WORK INSPECTION REQUEST (WIR) FORM

Contractor:	HAIF-FREYSSINET JV
Project:	RA2RC
Contract No.:	QPMO-410-CT-00618
Work Inspection Request Number:	QRXM114000-HFC-TEC-WIR-ITS-02-RO5-00002

Inspection request for Installation of Variable Message Sign (VMS)-5nos and 7mtr ITS Pole-5nos VMS-01,VMS-02 ,VMS-03 ,VMS-04 ,VMS-05 .Main Line-02 and Spiliting.

Project Name: Package 3 - Interim Road Access to Resort Core	**Project Code:** QRXM114000
**Location: RA2RC ** Qiddiya INTERM ROAD	**Date:** 14-February-2026
Document Title: Method of Statement for Installation and Commissioning of Intelligent Transportation System Equipment and Devices.	**Ref No: QRXM114000-HFC-TEC-MST-ITS-02-RO5-00001** **Rev No:** 00

Drawing title: ITS SHOP DRAWINGS
ITS LAYOUT PLAN

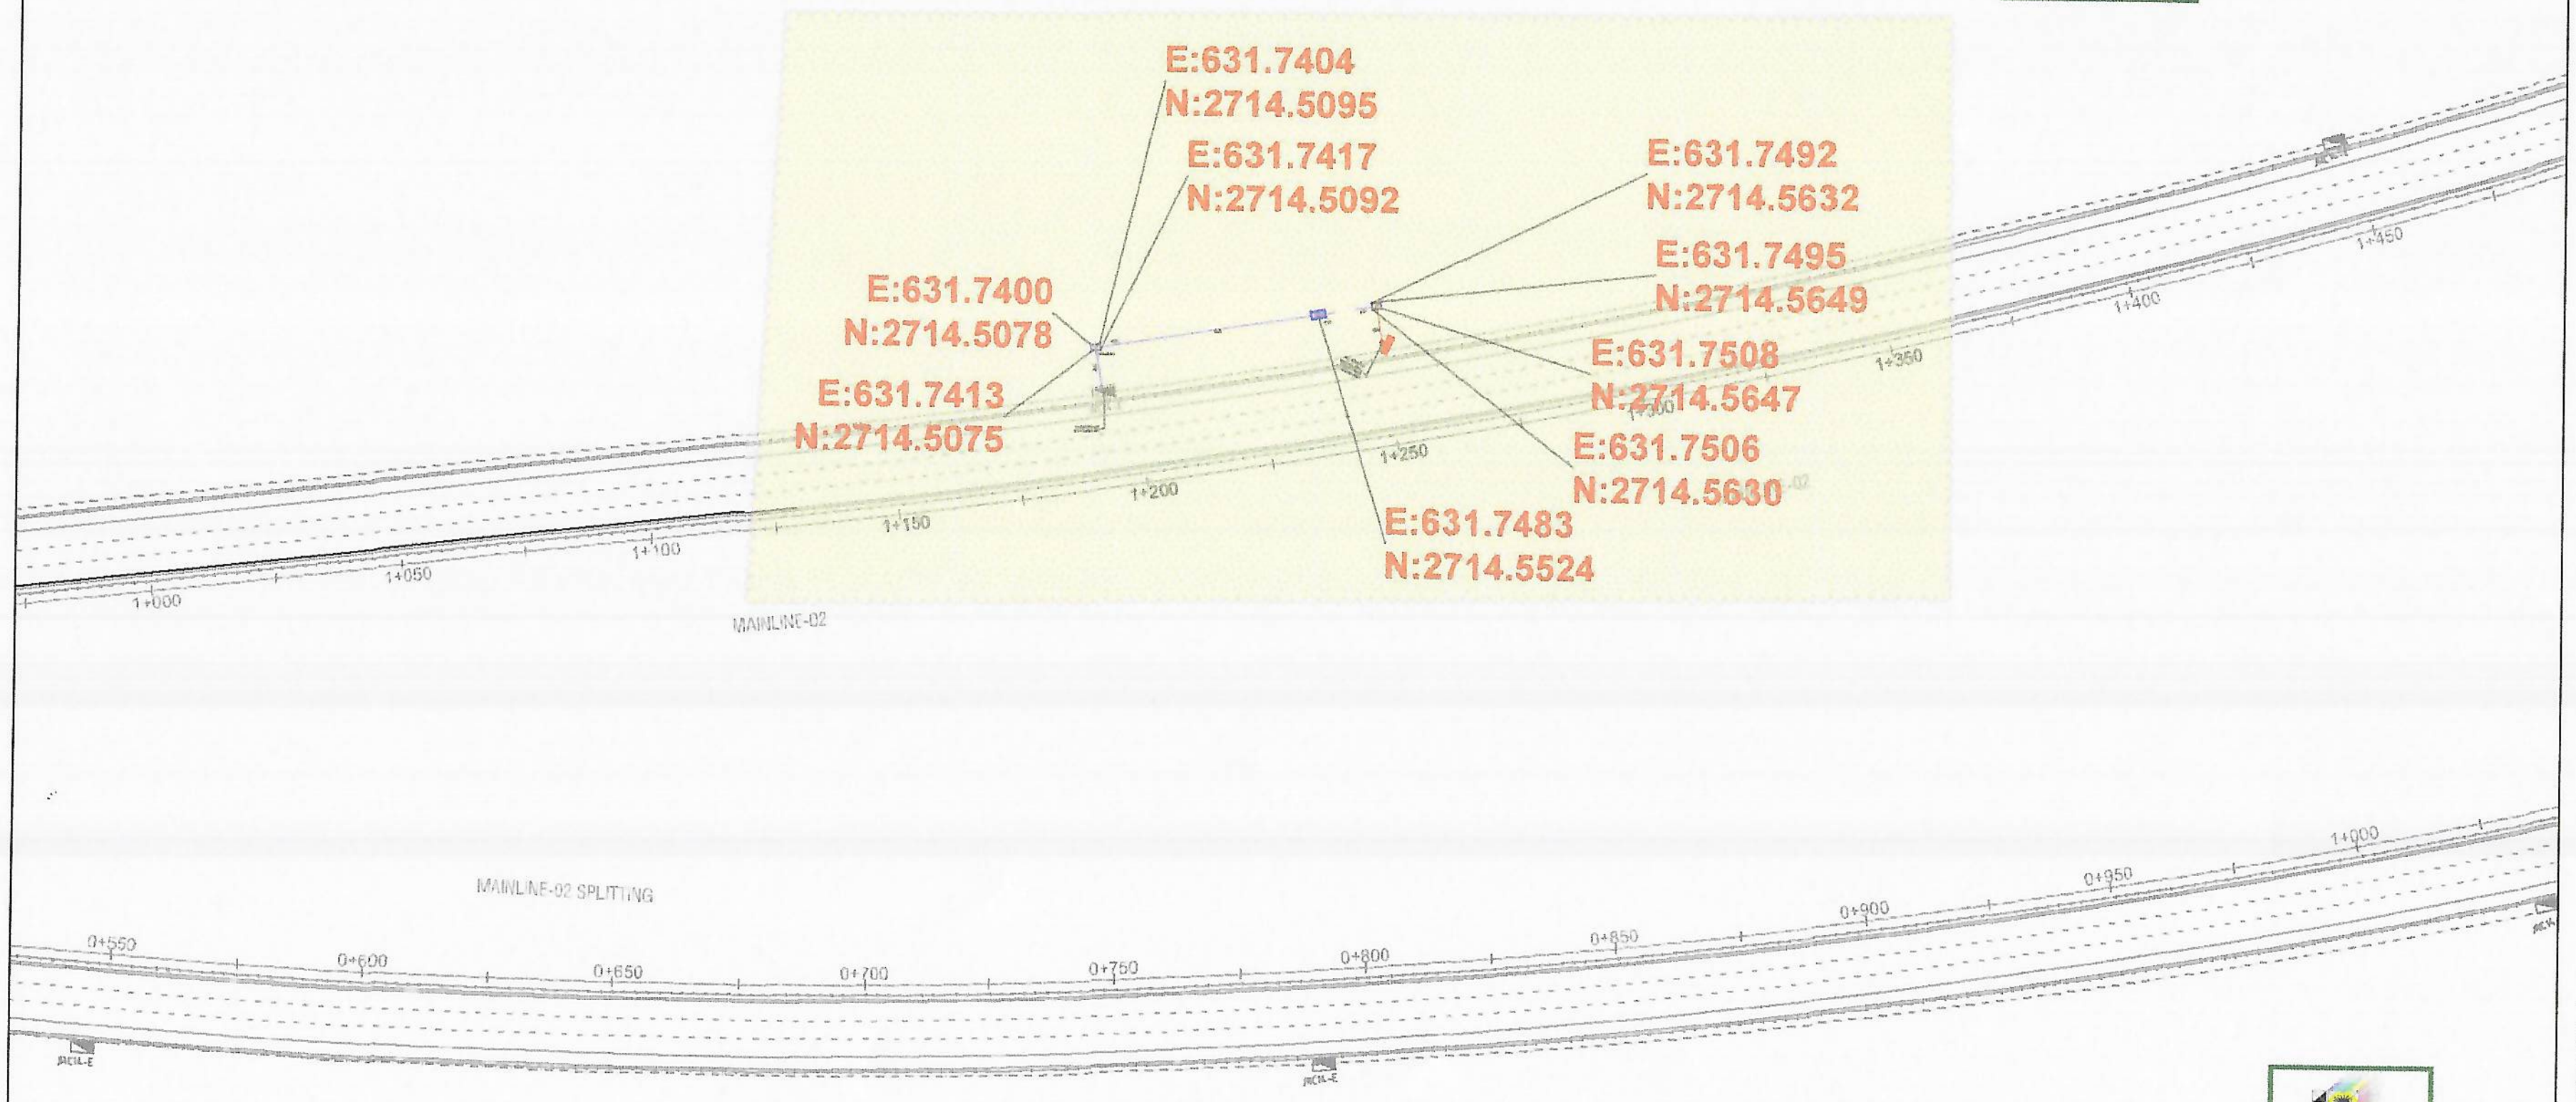
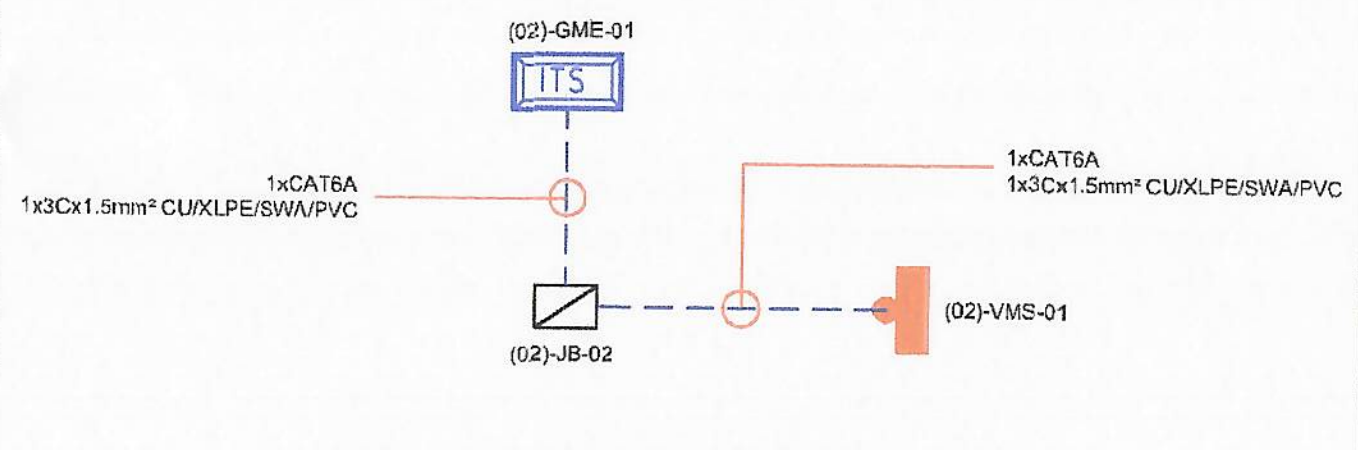
For comments refer to the drawing
#QRXM114000-HFC-DRW-SDW-ITS-02-RO5-00007

Drawing title:
ITS SHOP DRAWINGS
ITS LAYOUT PLAN

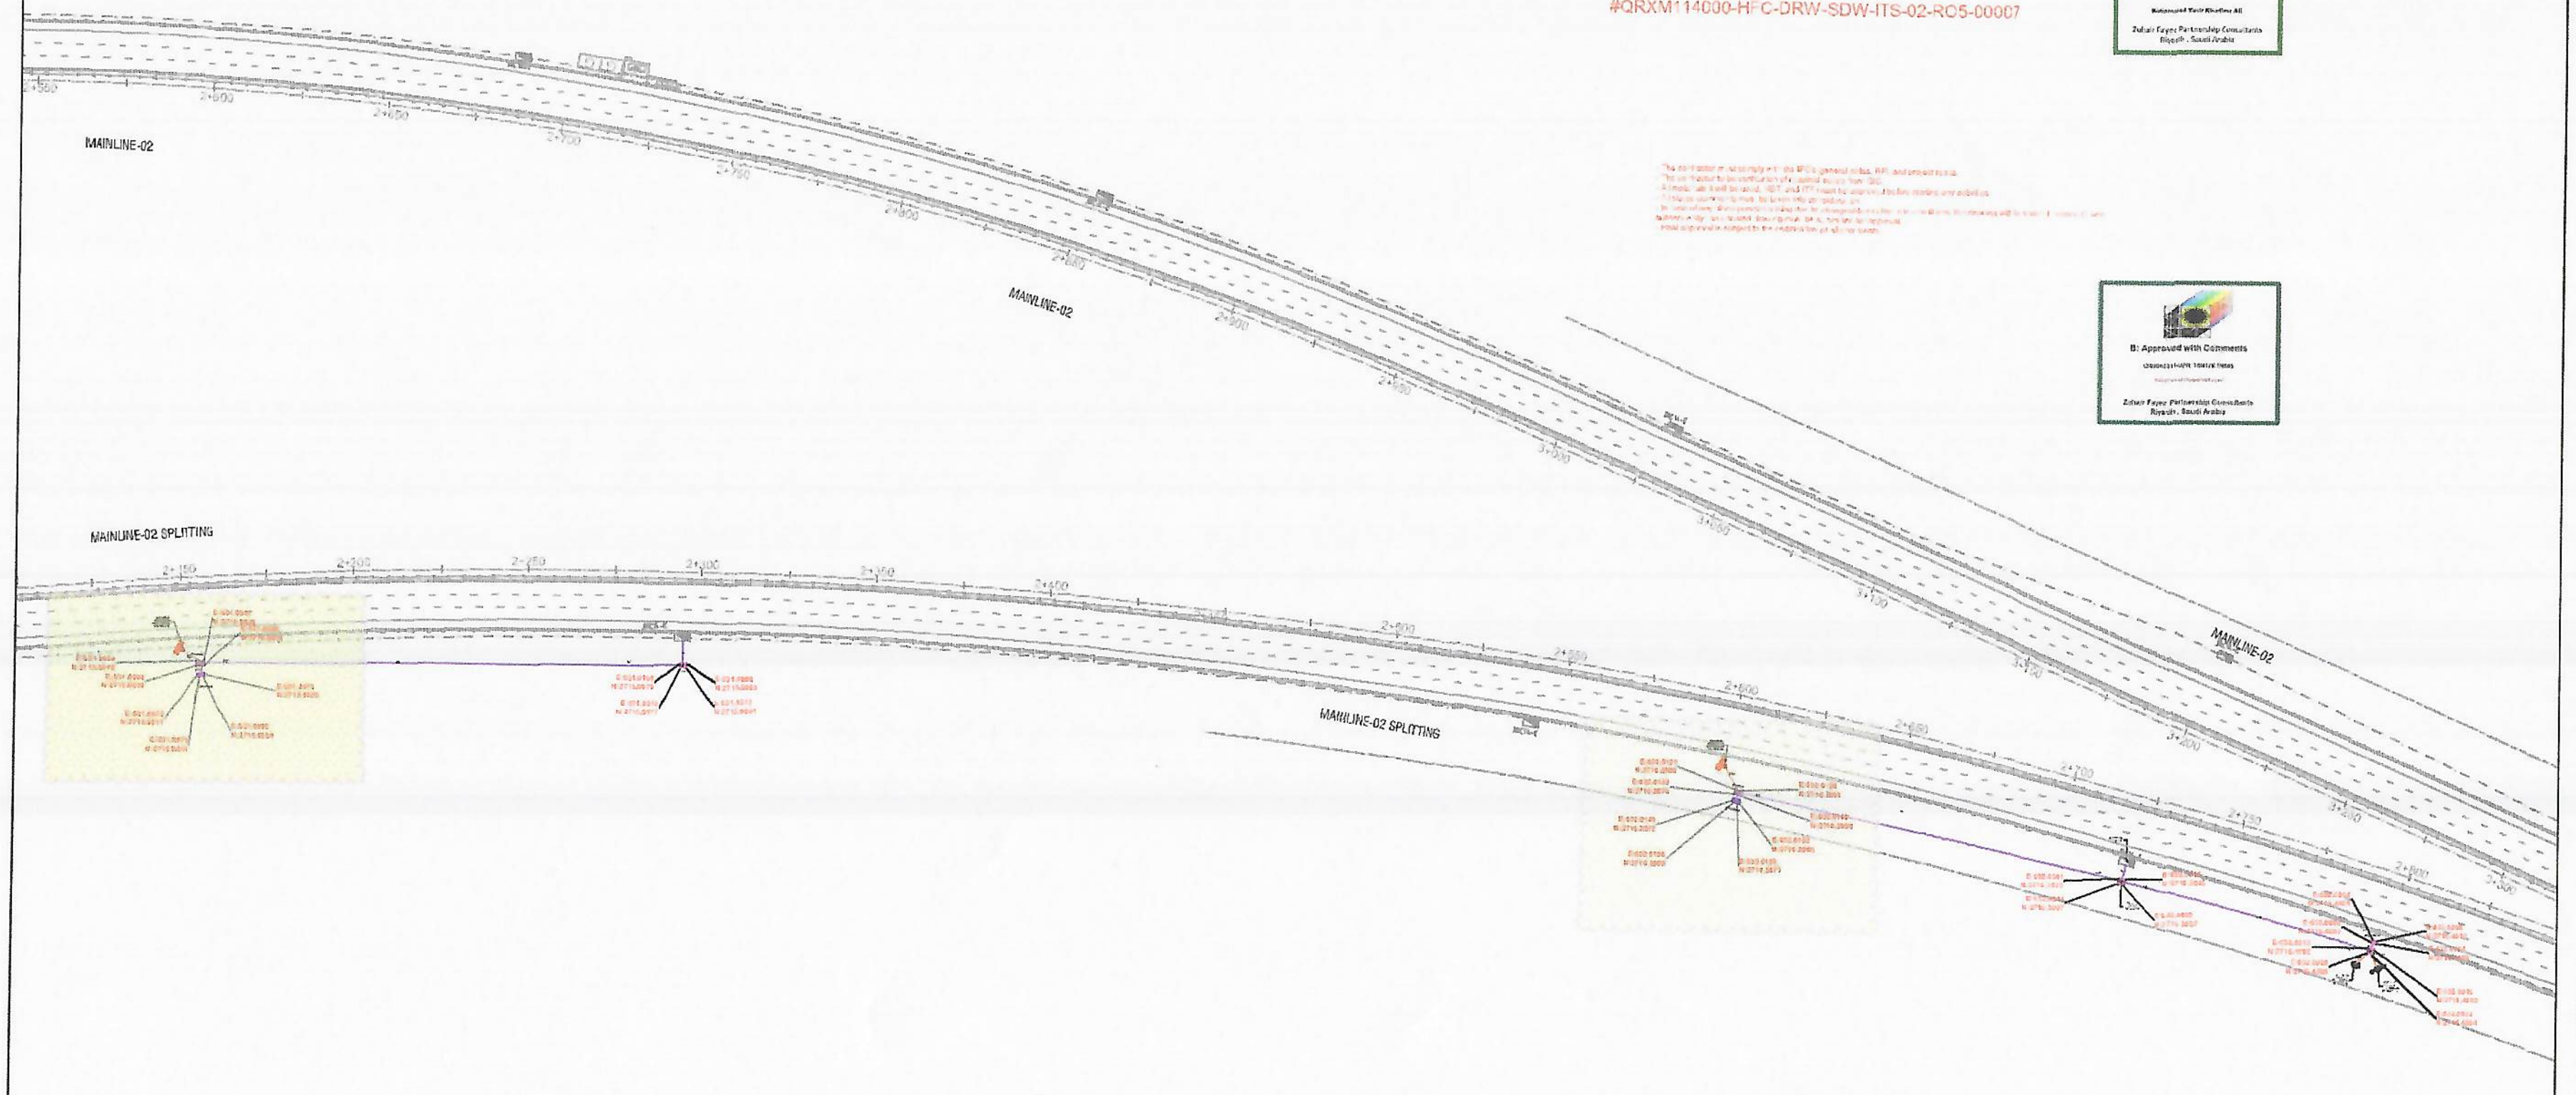
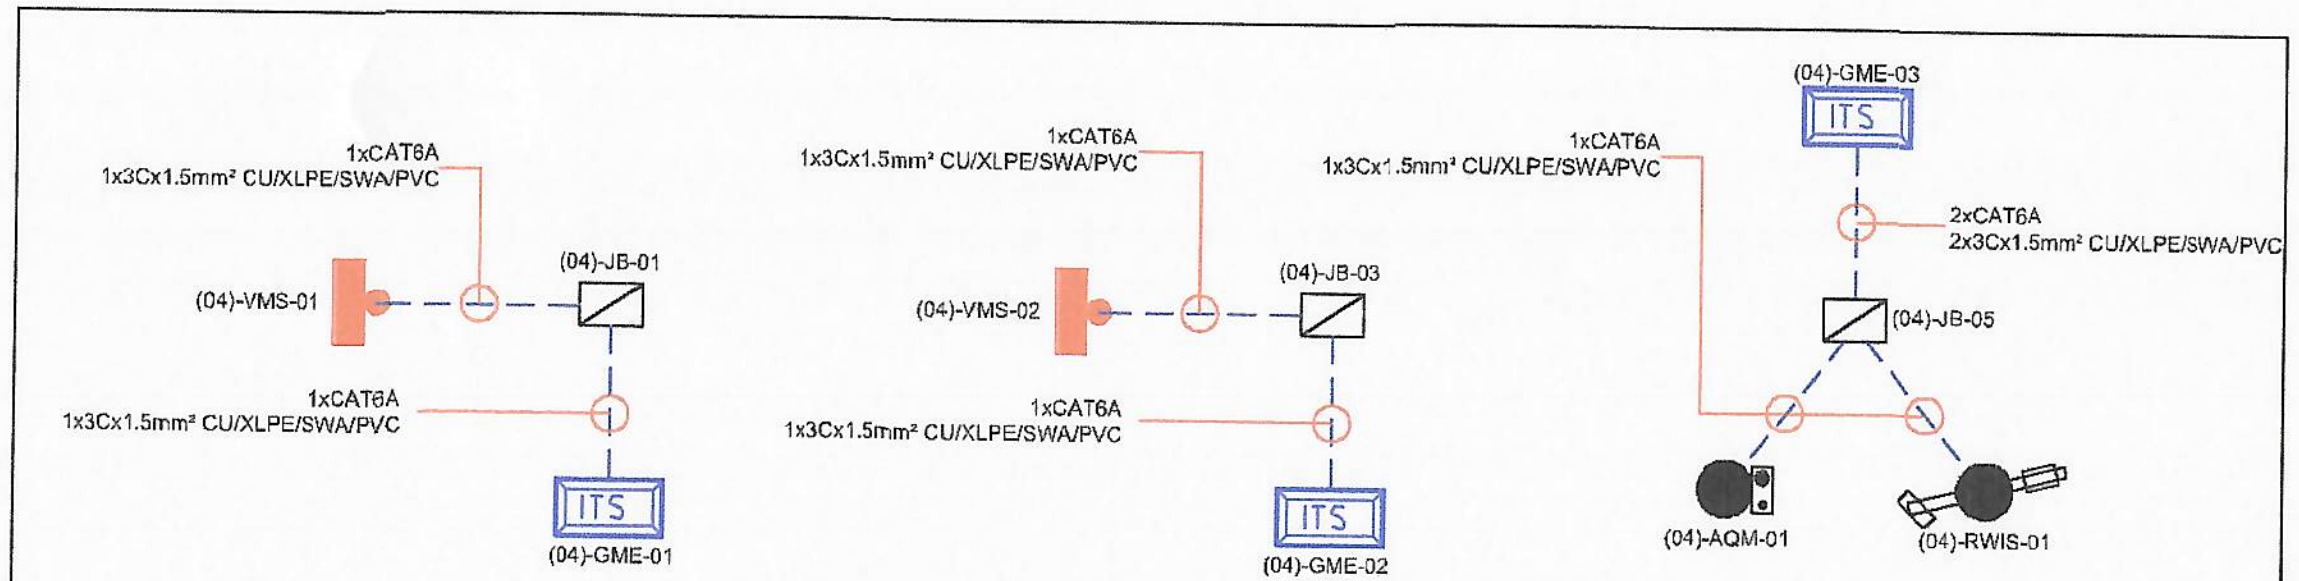
For comments refer to the drawing
#QRXM114000-HFC-DRW-SDW-ITS-02-RO5-00007
